-How is the resistance inside of the OLS measured? Is it a direct resistance measurement, or is it calculated via a voltage/current measurement? **Calculated via measured voltage**

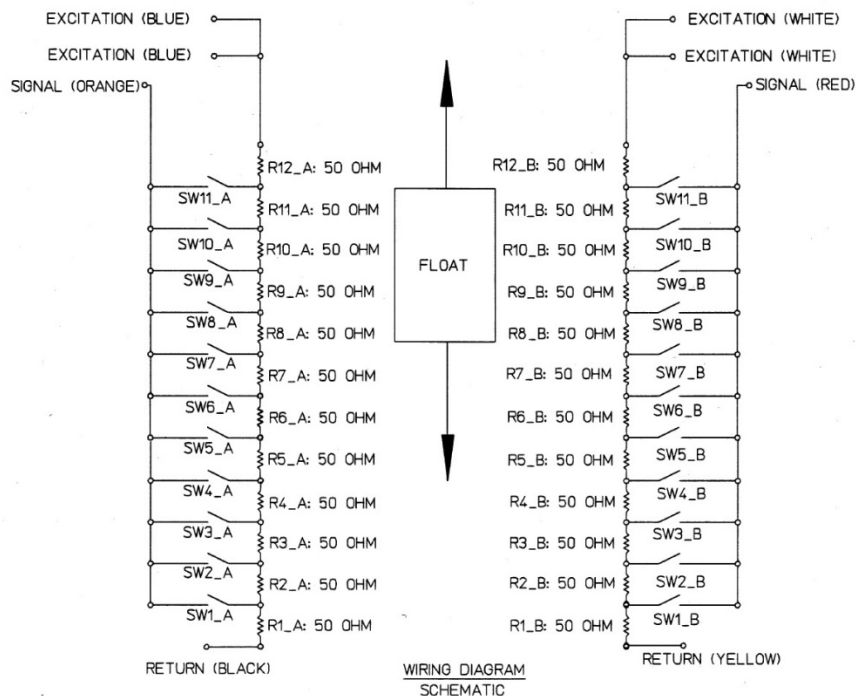
-Where is the constant current (0.25 milliamps) applied to the circuit? Is the diagram below correct? **Updated diagram below to illustrate how it is wired**

-Are both circuits in the OLS powered by the same constant current source, or separate sources?  
**no it has a separate CCS output**

-Is it possible to measure the input and output current from the circuit to the OLS?
